ALERT SERVICE BULLETIN

NO. 427-09-25

MODEL AFFECTED: 427

SUBJECT: STAKED BEARINGS, ONE-TIME INSPECTION OF.

Figure 1. Affected part Supplier marking.

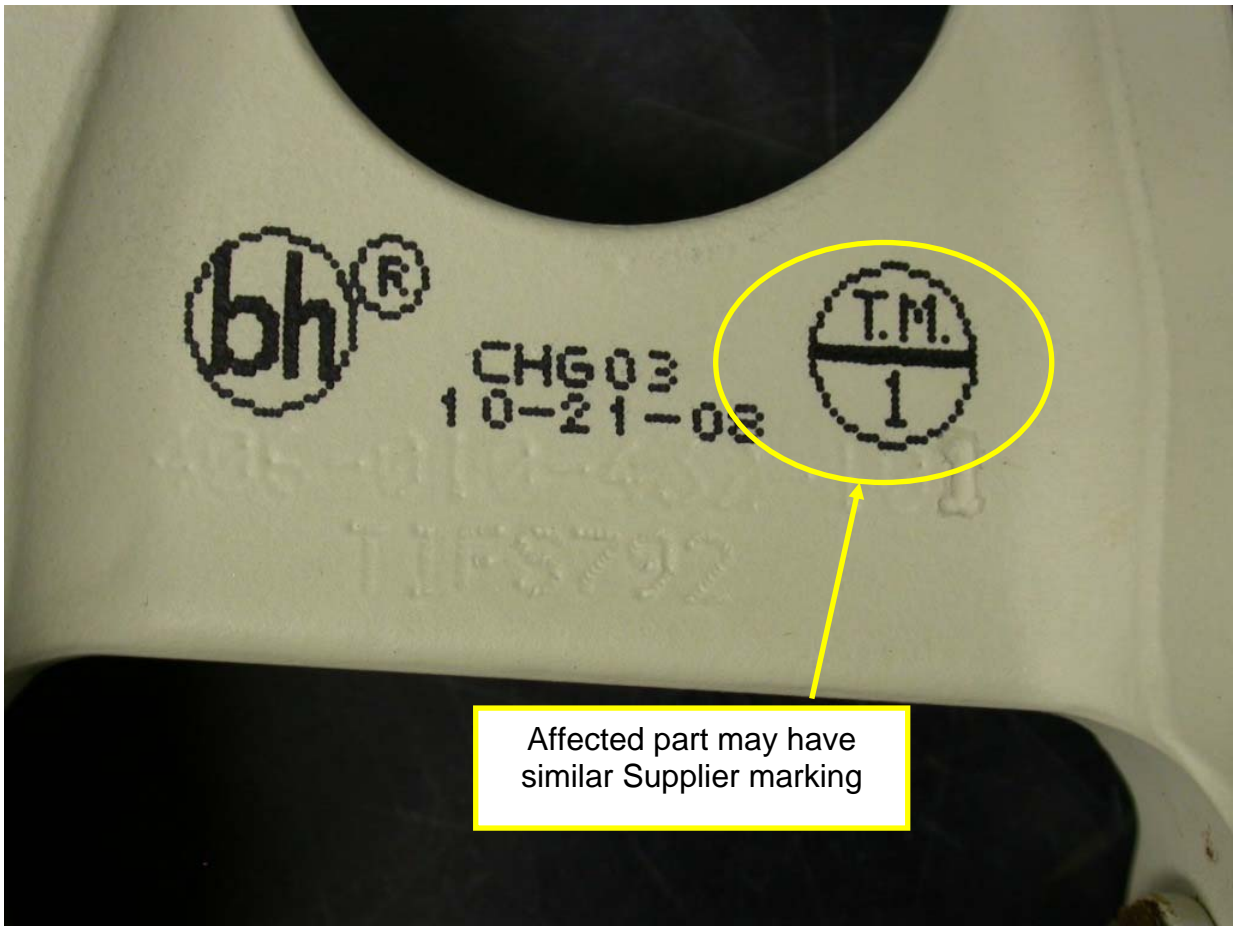
Bell Helicopter issues this bulletin to accomplish a one-time inspection of various parts that could potentially exhibit the same defect. The affected parts are listed in Table 1. Parts in service and all spare parts are affected. When serialized, only parts with serial number prefix TI or TIFS are affected. However, affected part not serialized, may have Supplier marking as shown on Figure 1.

1. Gain access to the affected parts. See Table 1 for the list.
2. Using a 10X magnifying glass or other suitable means such as a boroscope, inspect parts for bearings that have not been staked. Refer to Standard Practices Manual (SPM). If a bearing is not visible, apply hand pressure to the part to detect any axial movement. If still in doubt, remove the part from the aircraft to inspect.
3. Should you find a part with a discrepant bearing, replace the bearing or the assembly and contact Product Support Engineering to report finding.
4. Make an entry in the helicopter historical records indicating compliance with this Alert Service Bulletin.
